Report to Development Permit Panel

Re: Application by Matthew Cheng Architect Inc. for a General Compliance Ruling
at 7411 Moffatt Road (formerly 7411 and 7431 Moffatt Road)

DP AMENDMENT RATIONALE

RE: 7411 MOFFATT ROAD
RICHMOND, B.C.

Sheet Title
 SITEPLAN
 SECOND FLOOR PLAN
 (AS BUILT/PROPOSED)

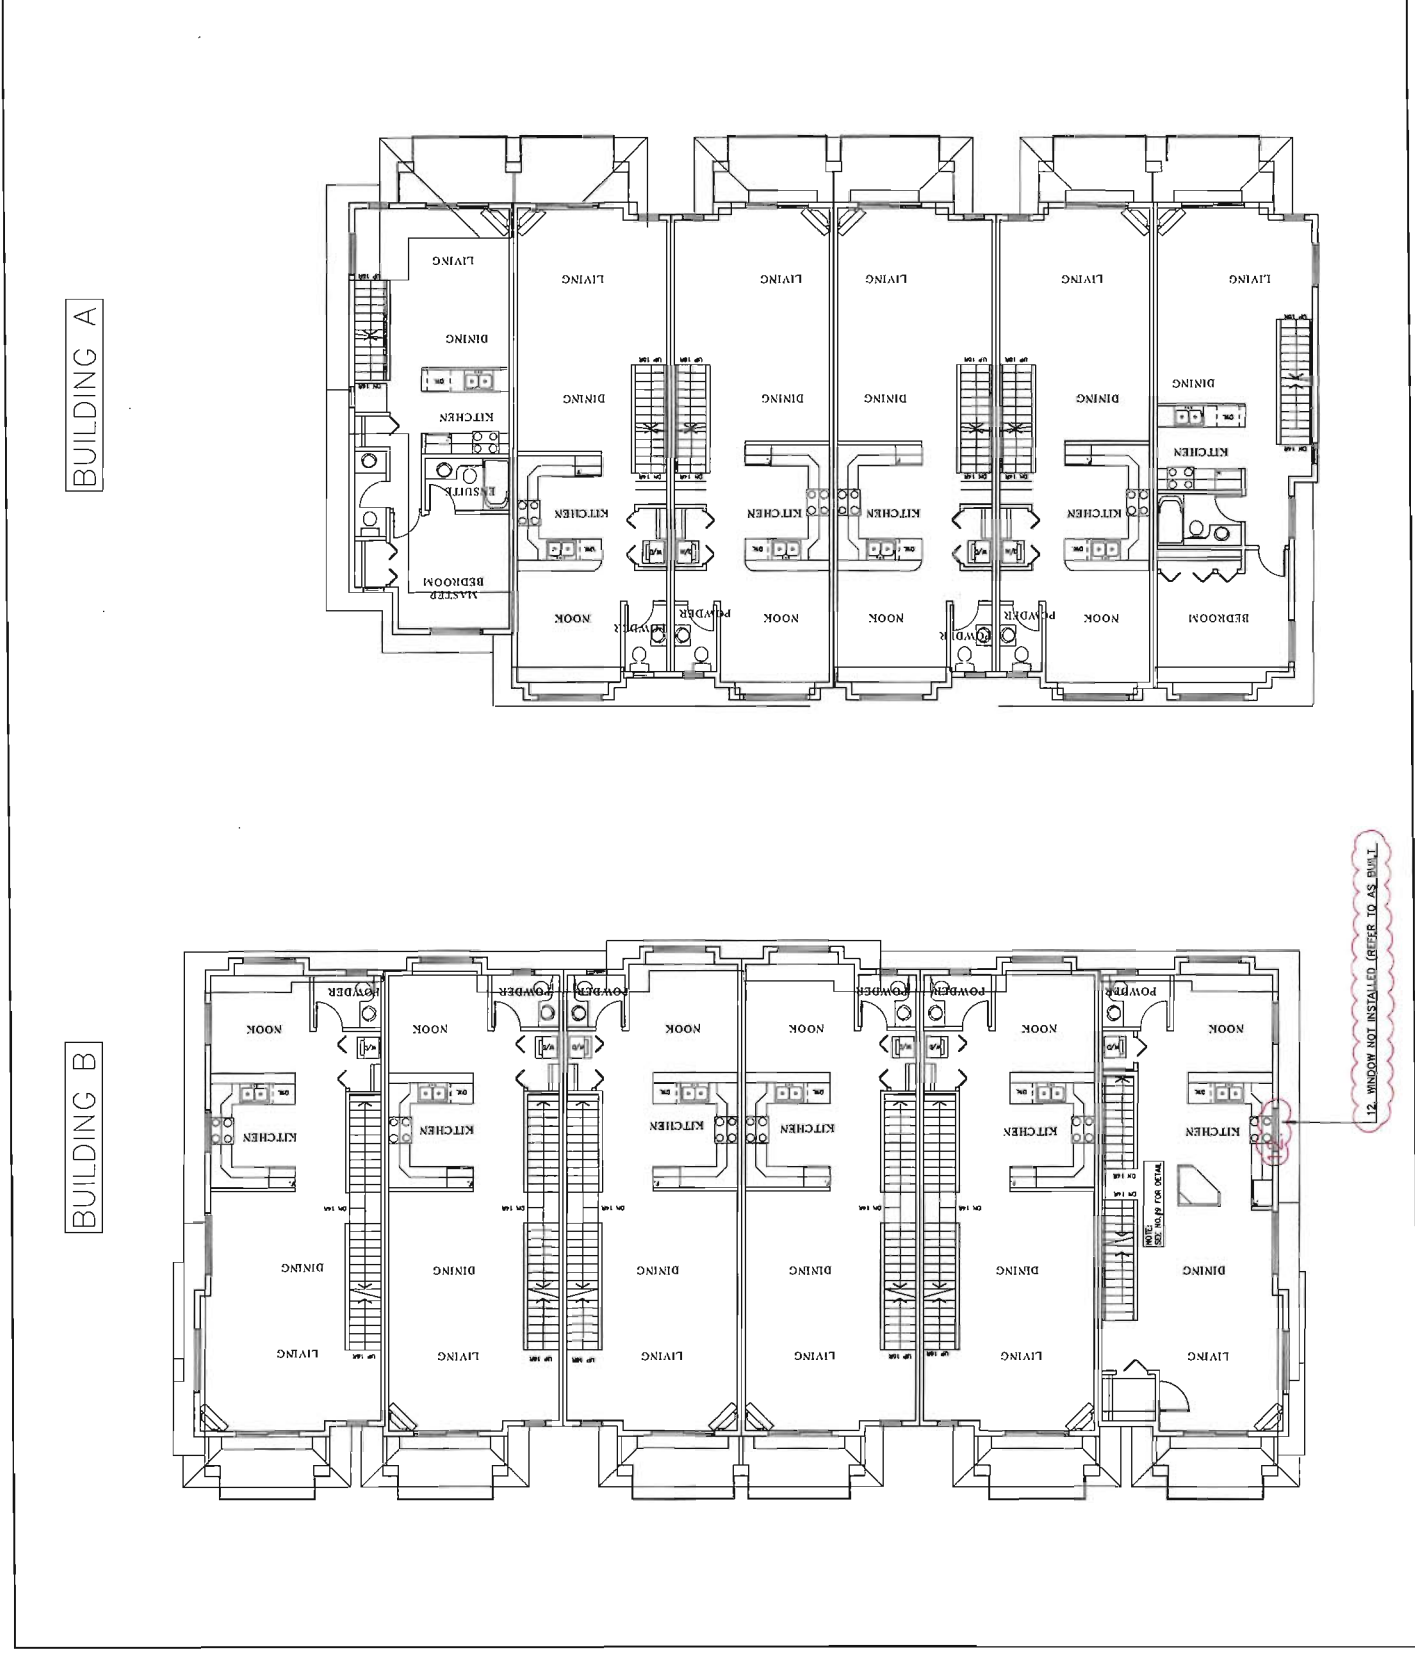
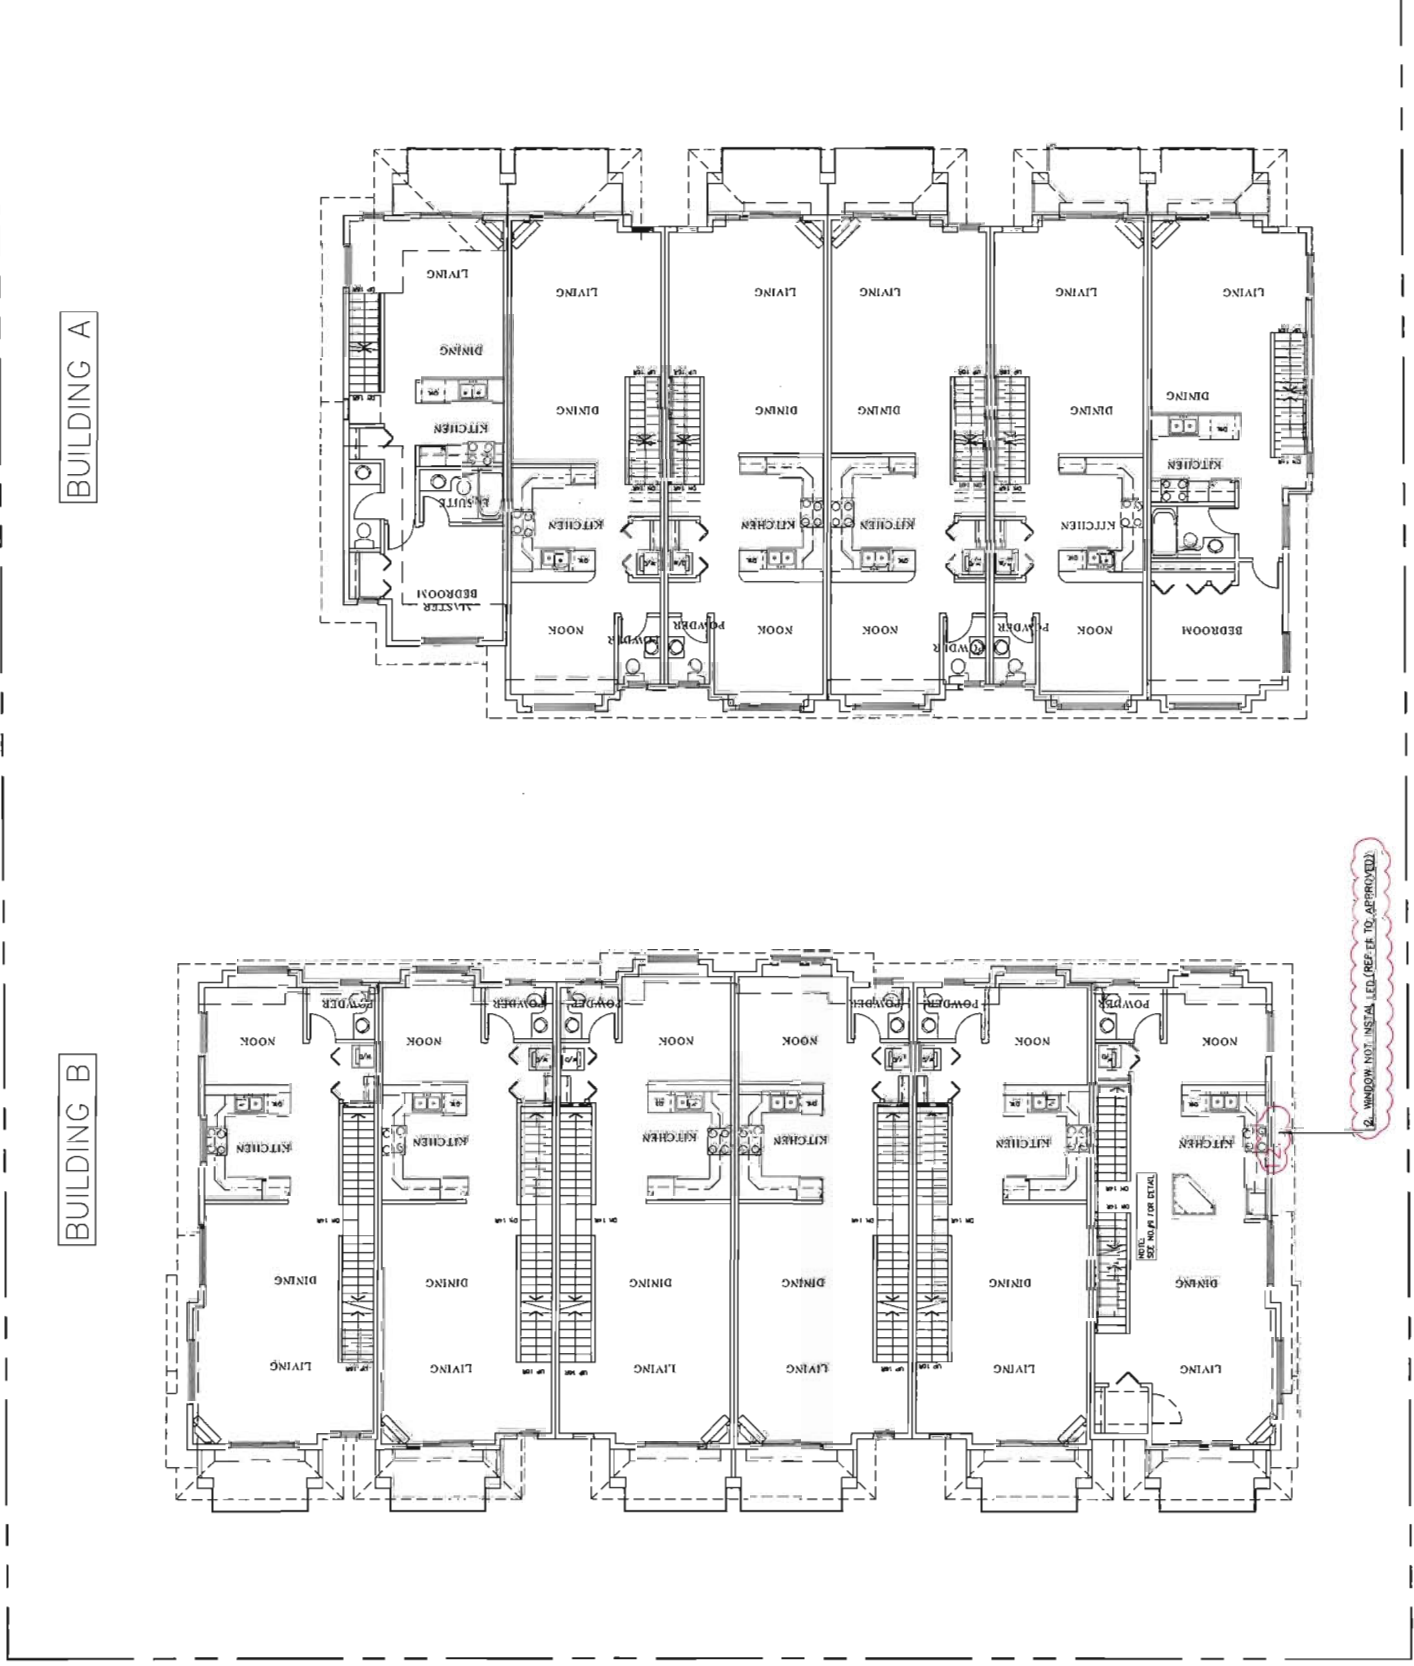
- **Affected Area #12** - On the South elevation and the second level floor plan of building B, a window is removed due to practicality issue as the location of stovetop is aligned directly with the window and also to avoid condensation issue. (See Sheet 4B & 5B – As Built/Proposed)

Affected area No19

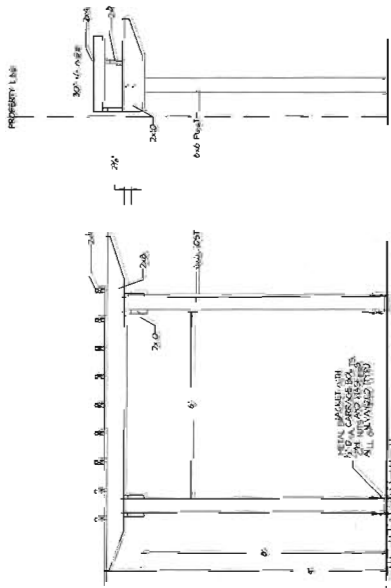
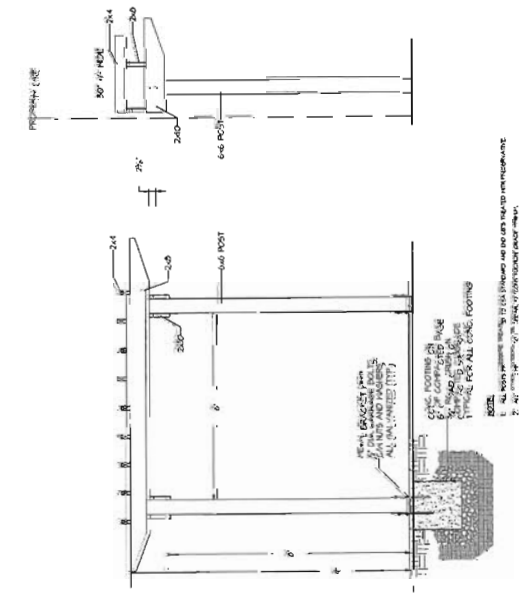
The Frances Andrew Bench; Centennial, Model C22-3a; Black Colour was substituted with a similar bench: the Frances Andrew Bench; Basic-Series 1- Model B1-3; Black Colour because of availability at the time of construction. The Landscape Plans have been amended to show the substituted bench. (See L1"As Built/Proposed" and L1"Approved").

4 STREET FRONTAGE - 42" HT FENCE WITH GATE
 Note: Mechanically fasten the cedar panel to the aluminum channel from the bottom to fixate the cedar panel in place.

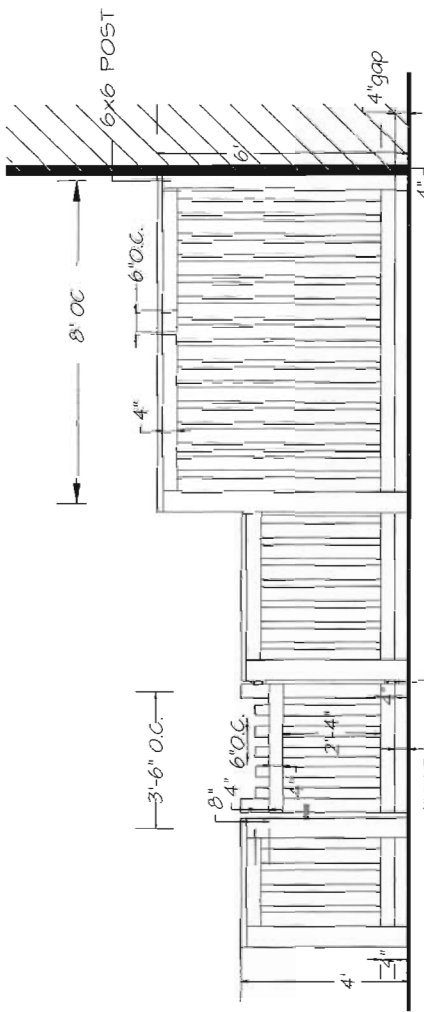
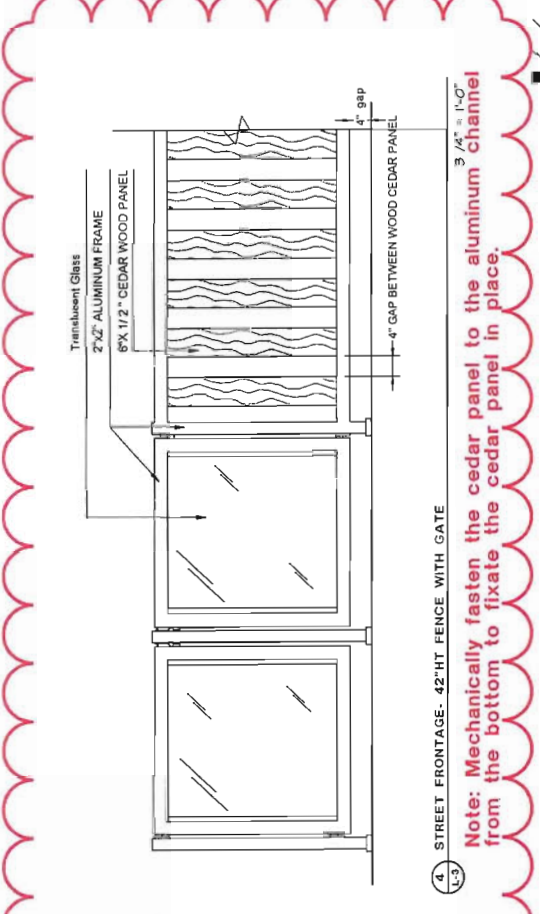
The as-built fence was upgraded from the proposed black aluminum rail fence to a fence with better transparency and improving the curb appeal in harmony with the existing exterior material used. The detail and use of vertical cedar panel is a continuation of the balcony detail. The fence now provides 4 inch spacing between the cedar panels.

The DP shows a staggered line location of the fence along the street frontage. The developer will move the street fronting fence on two middle units back 24" to replicate the staggered fence line per design intent of the DP. (See L1, L2 Landscape Plan and Details and L1 and L2 As Built/Proposed").

The proposed black aluminum rail fence was upgraded to a unique fence the developer had specifically built to match the contemporary balcony detail.

5 6' HT PATIO SCREEN AND 4" HT WOOD FENCE WITH GATE
 Note: The gap has been changed from 4" to 3"

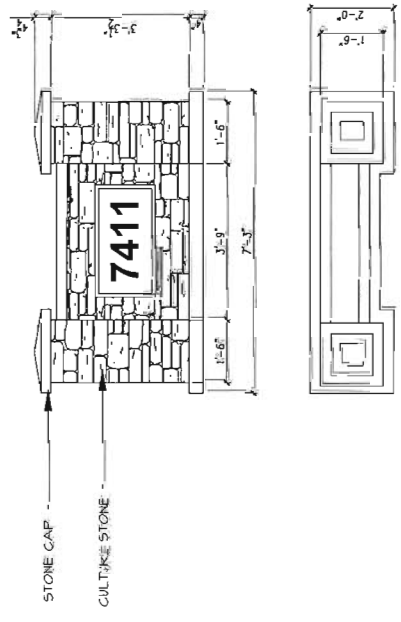
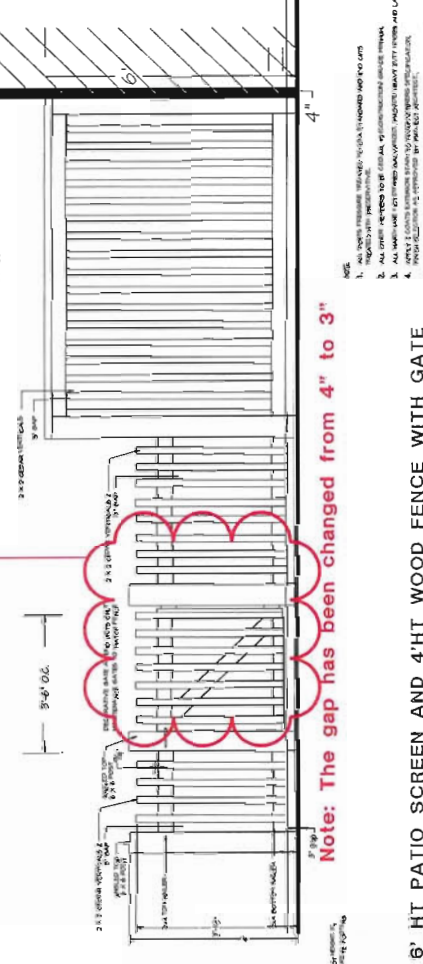
The fence and gate design for Units 1-6 has been revised to increase transparency and create a blend in harmony with the context and landscape around the building. The amended open fence will provide the design intent of better transparency and light for the small back yards. The change in design of gate and fence highlights the verticality of the material used in the complex.

Affected area No13

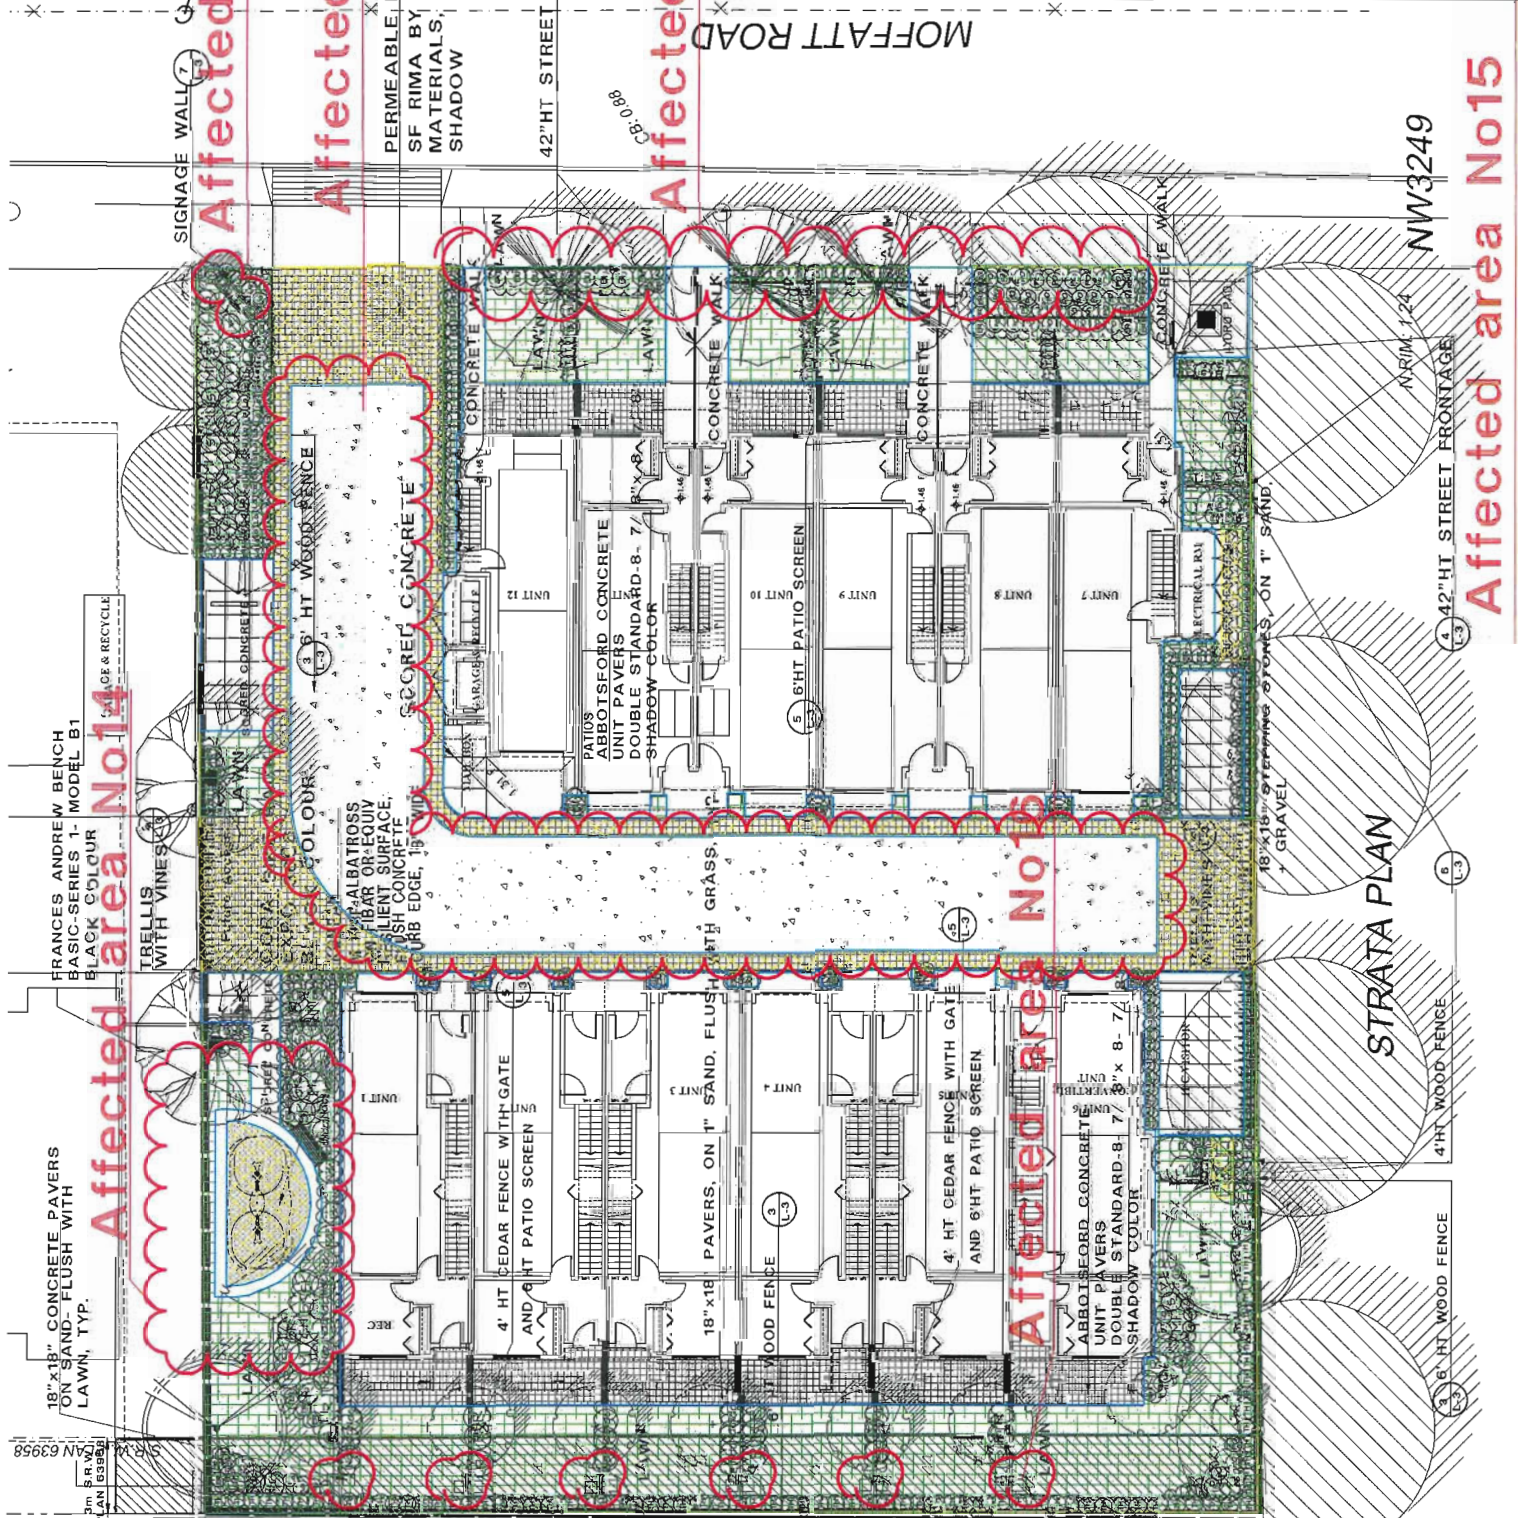
During the development process it was recommended that a shared children's play area between this site and the site to the north would be encouraged. We showed how this shared play would work and for development permit we revised the landscape submission to show the half of that play area developed on our site and removed the half that would be built on the neighbouring site.

Plant Schedule has been revised to show changes in plant material. The design intent of the DP drawings is the same. The number and size of trees remains the same as DP drawings. There are consistently 23 trees on each version of the landscape plans- all as built are of size and quality species.

The extent of porous pavers was co-ordinated with civil engineer. The permeable paver layout matches the design intent as proposed and meets Richmond's standard minimum. The as built area of pavers provides for a generous amount of pavers. It also reflects an approach that most other Townhouses of this scale have built.
